ADDENDUM NO. 2

BID NO. 2838

**CLOVIS EAST HIGH SCHOOL CTE FARM AND FOOD PRODUCT FACILITY
CLOVIS UNIFIED SCHOOL DISTRICT
CLOVIS, CALIFORNIA**

G.A. PROJECT NO. 1739

S3.1

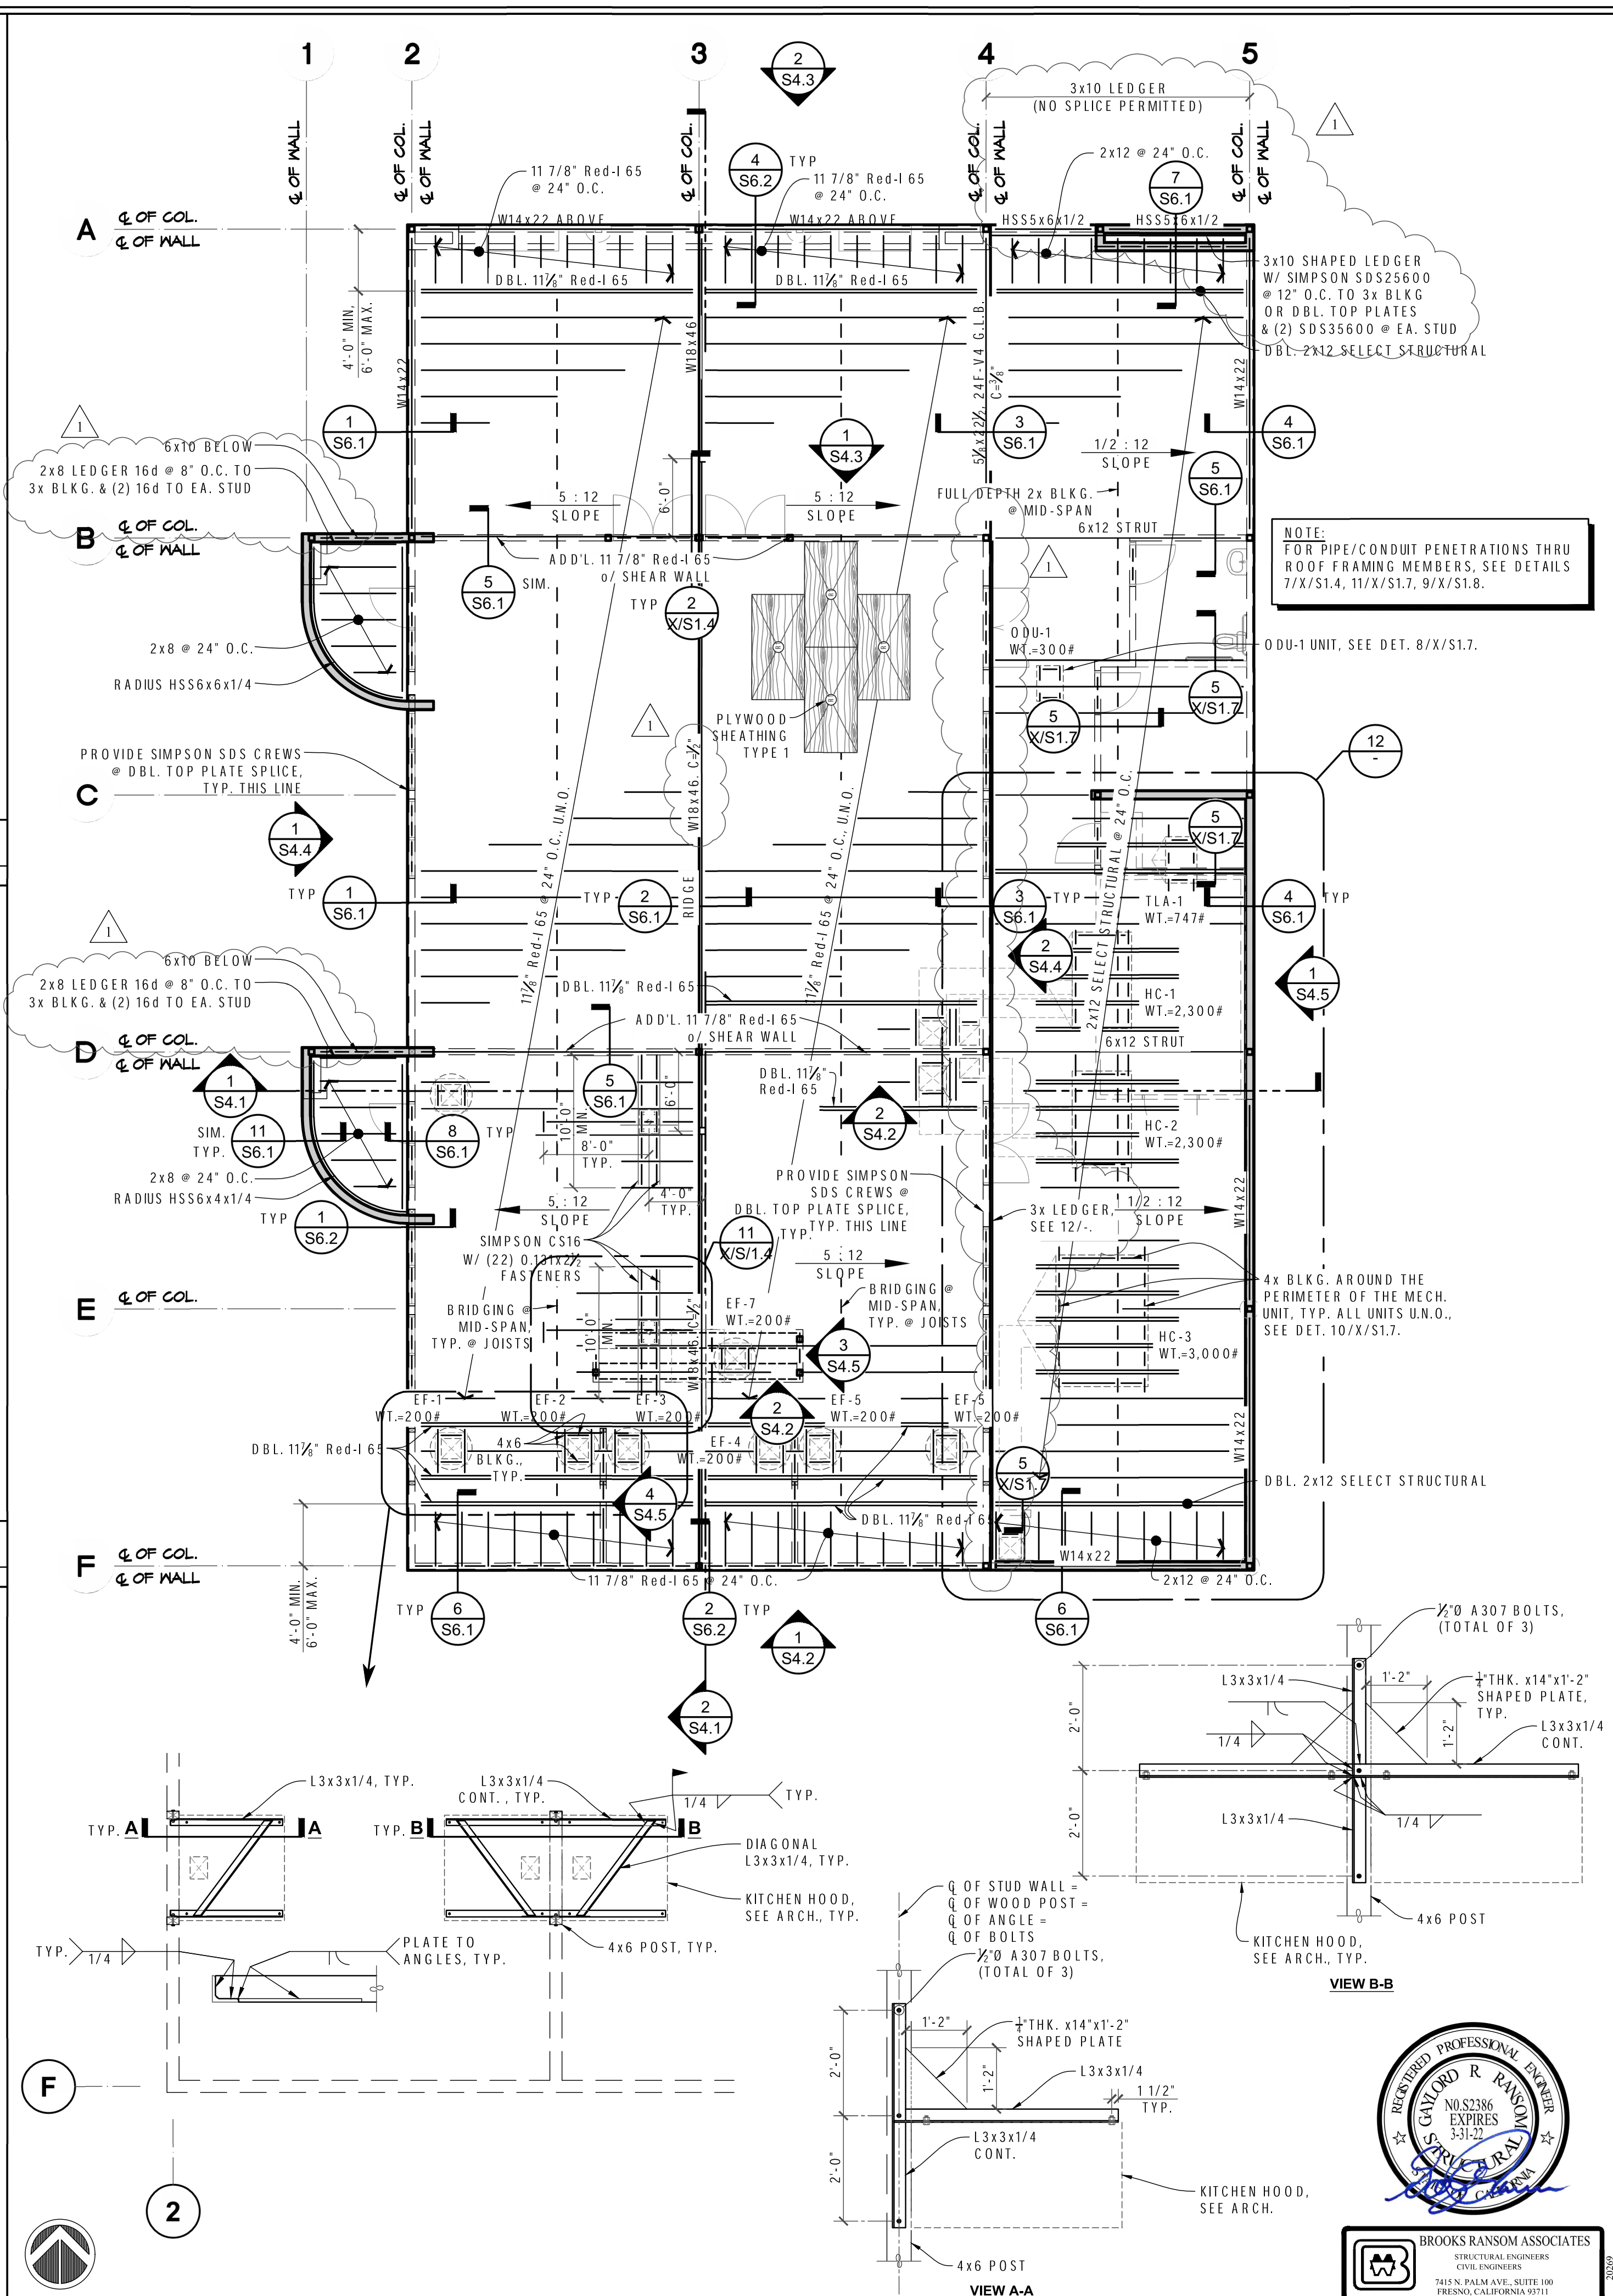
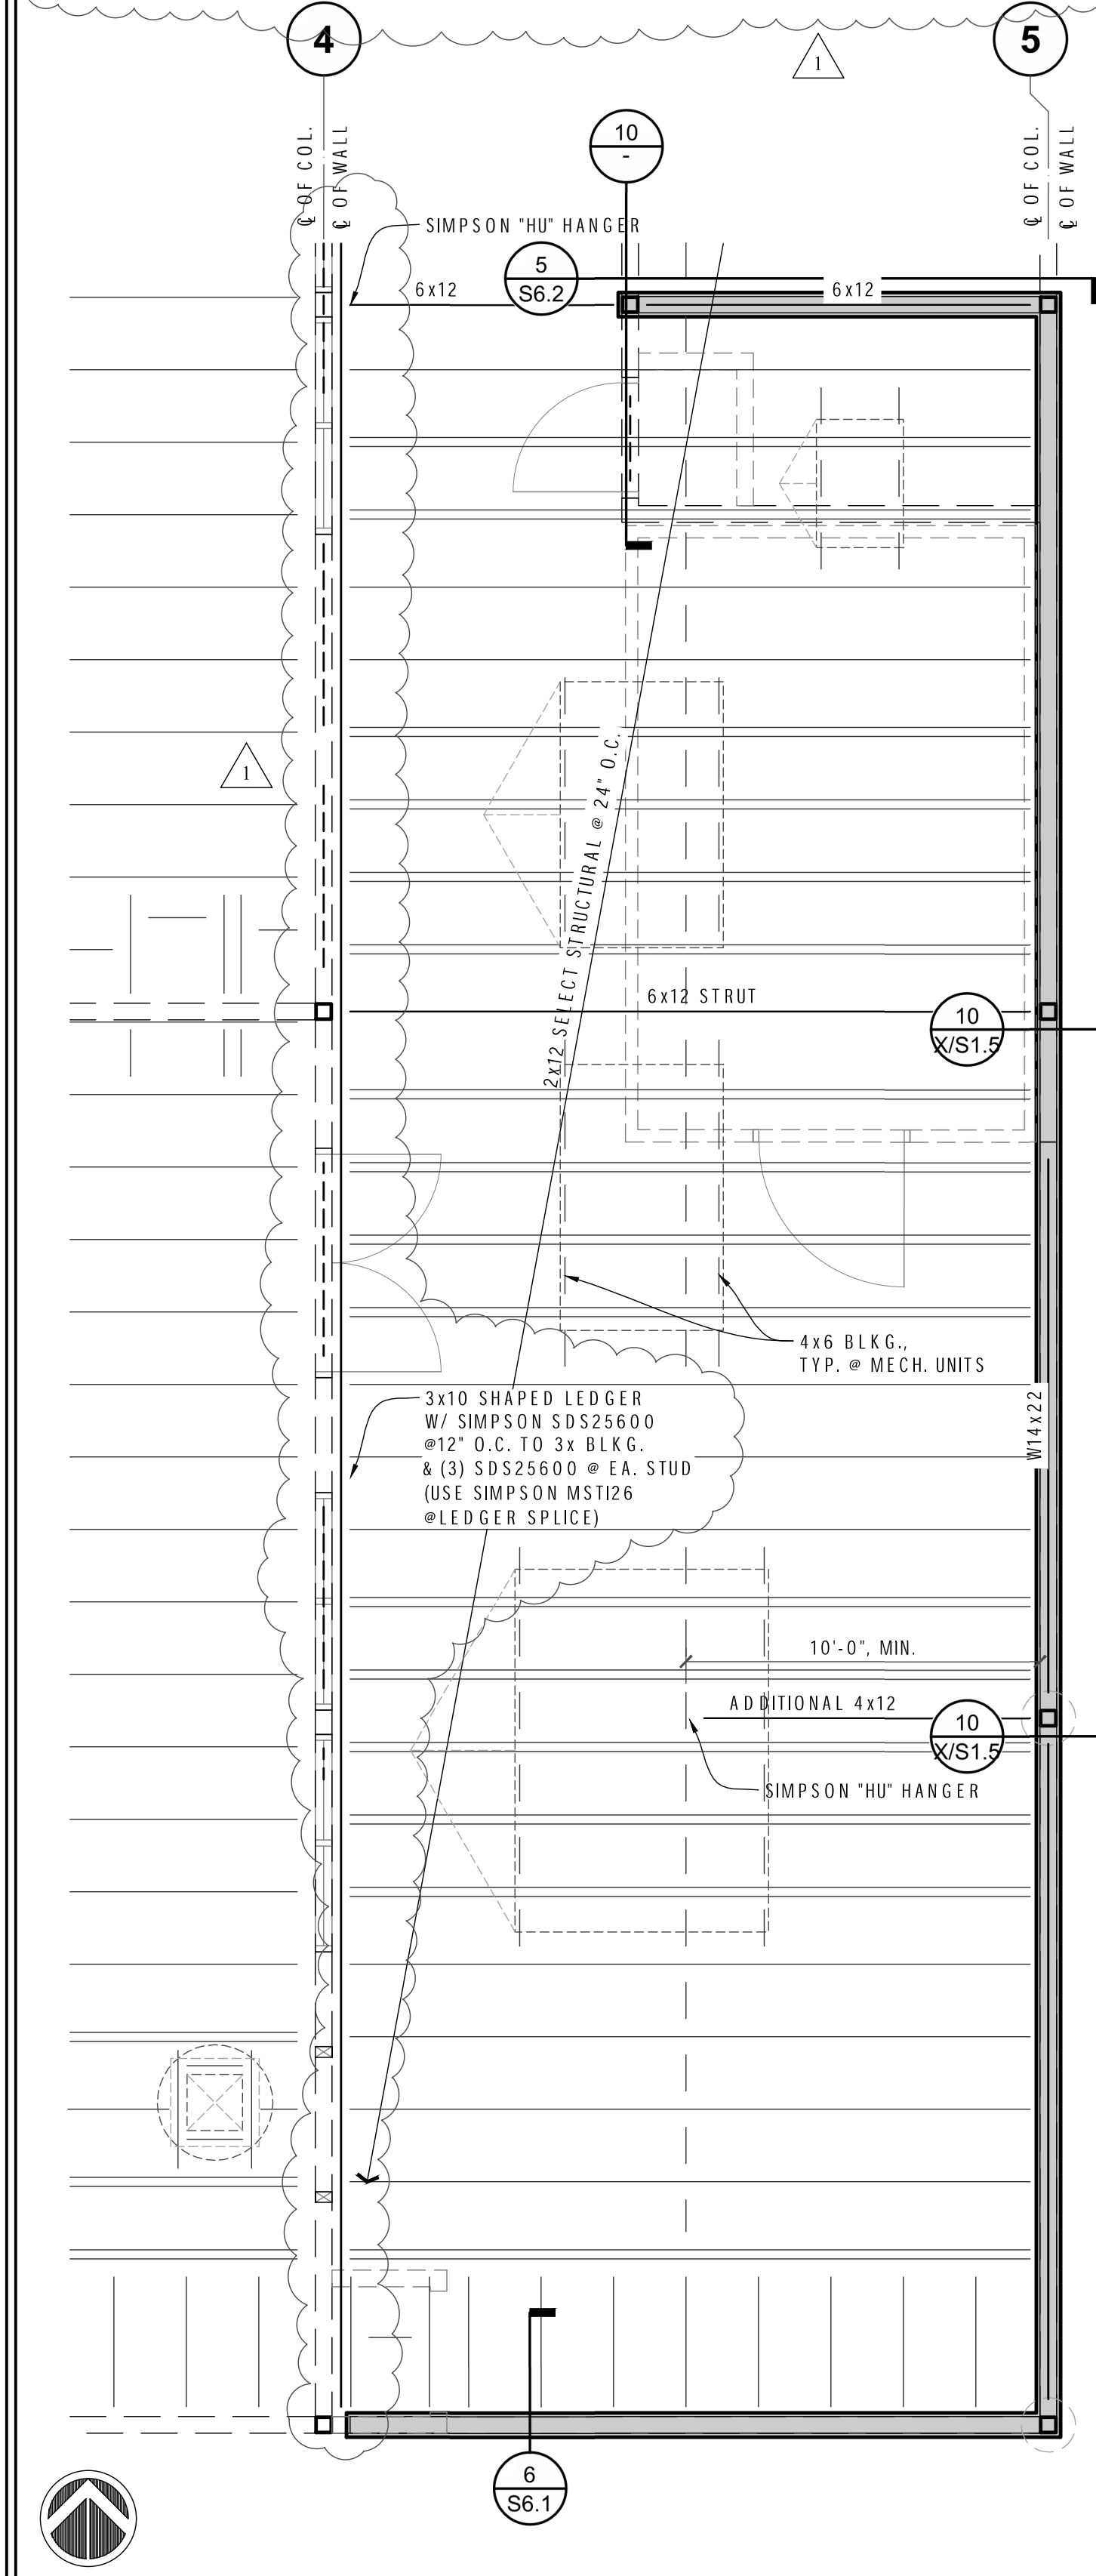
S3.1:

- 1.) Revised and clarified ledgers on plans.
- 2.) Added and clarified beam camber.
- 3.) Added column bracing to roof diaphragm detail 10.

S4.1

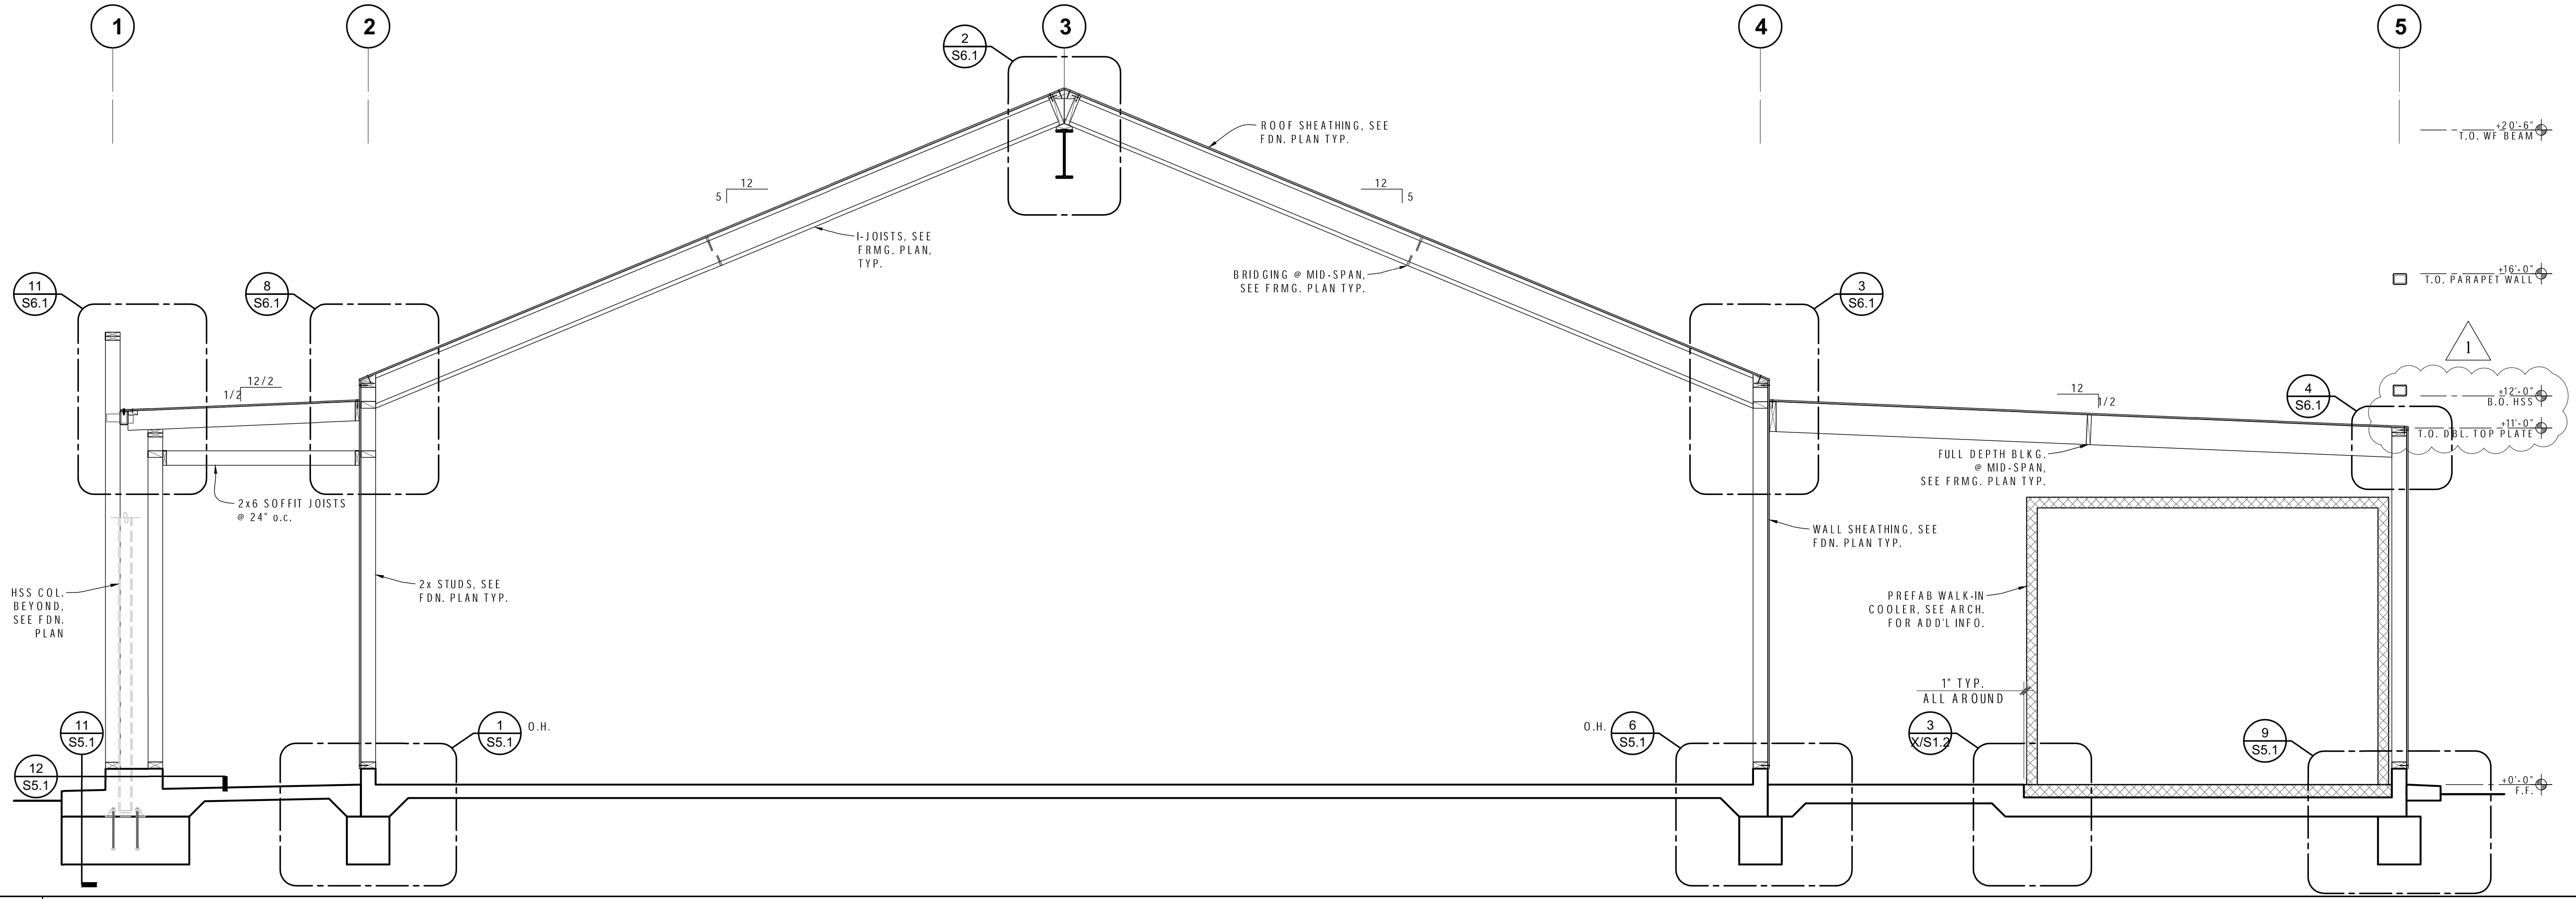
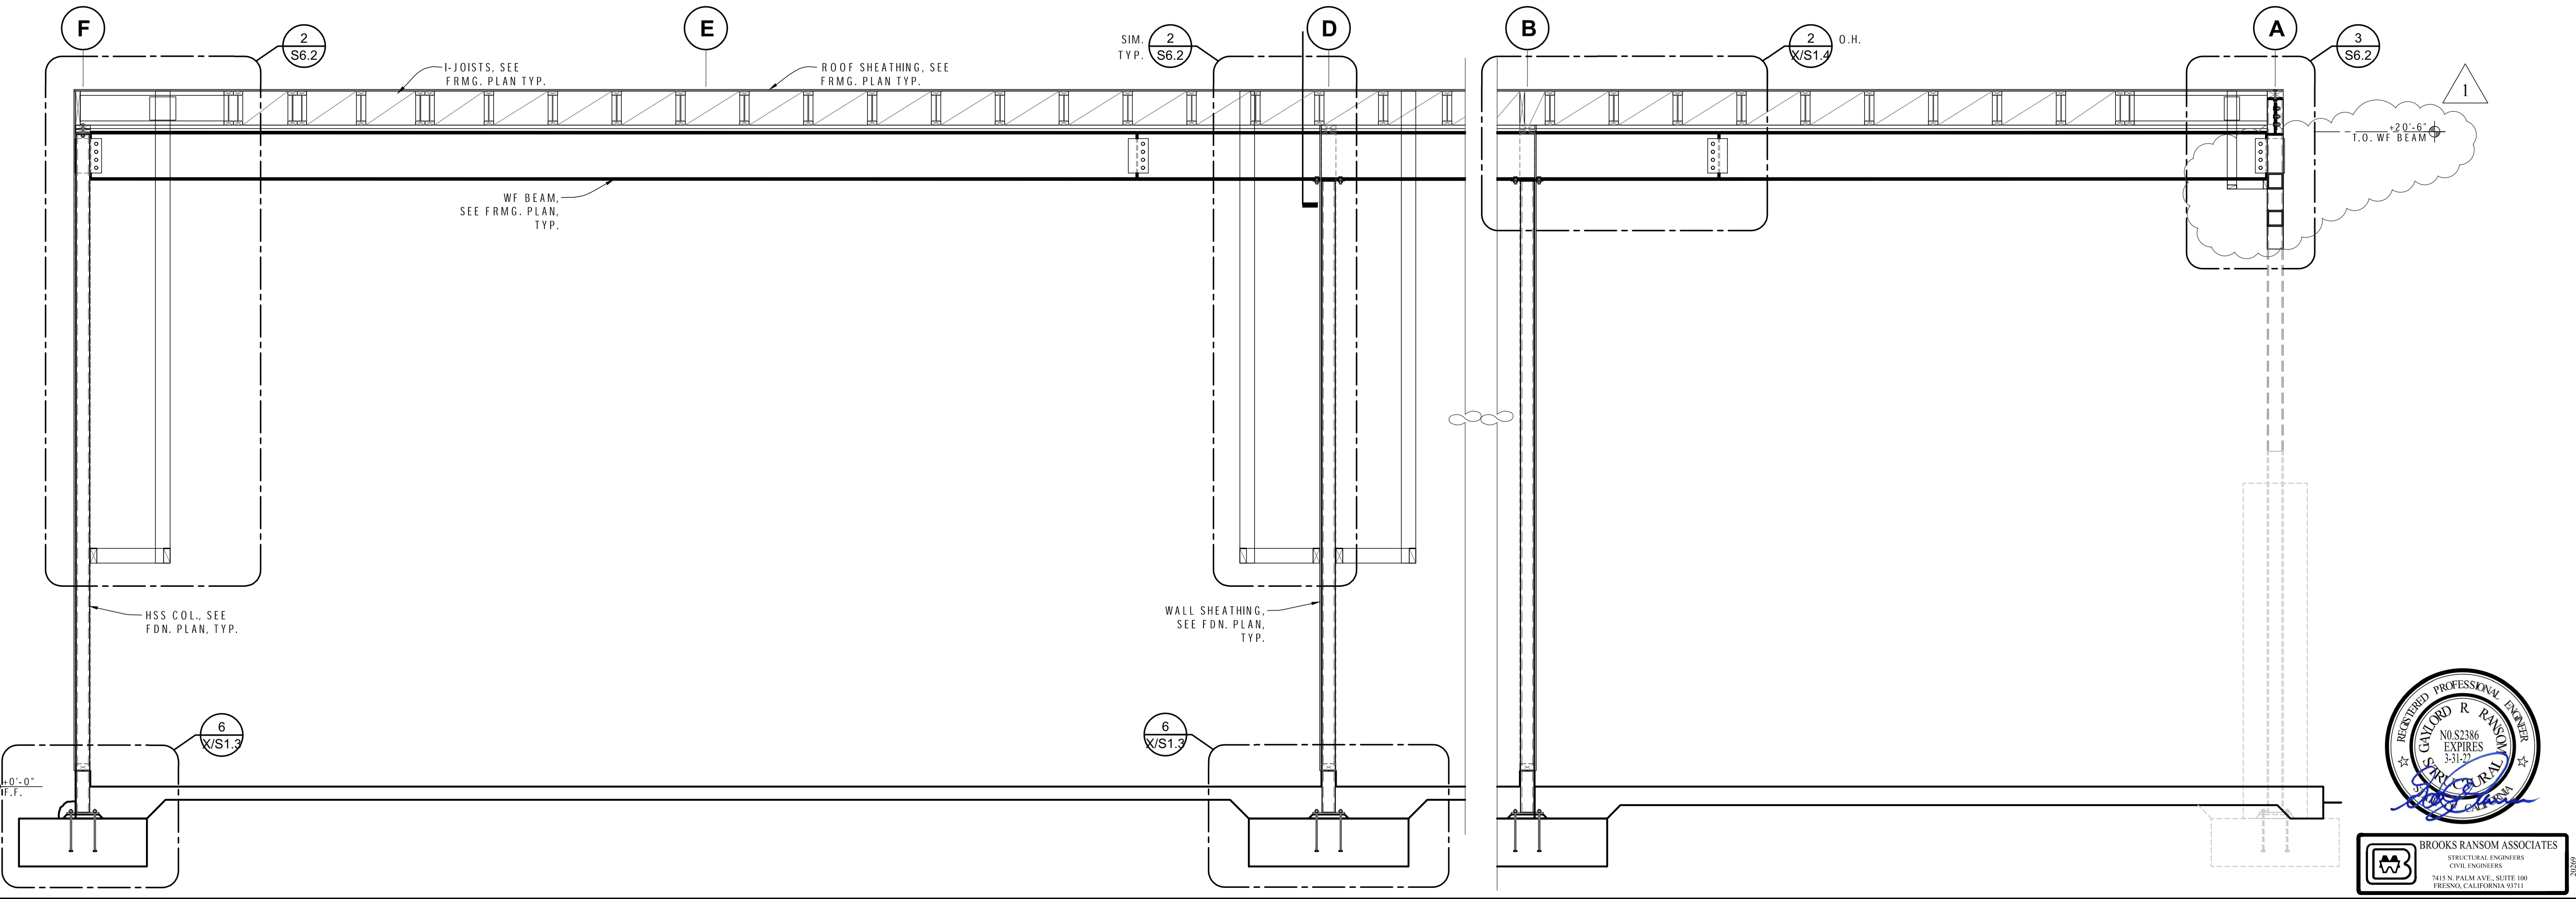
S4.1:

1.) Revised and clarified elevations and extent of soffit.
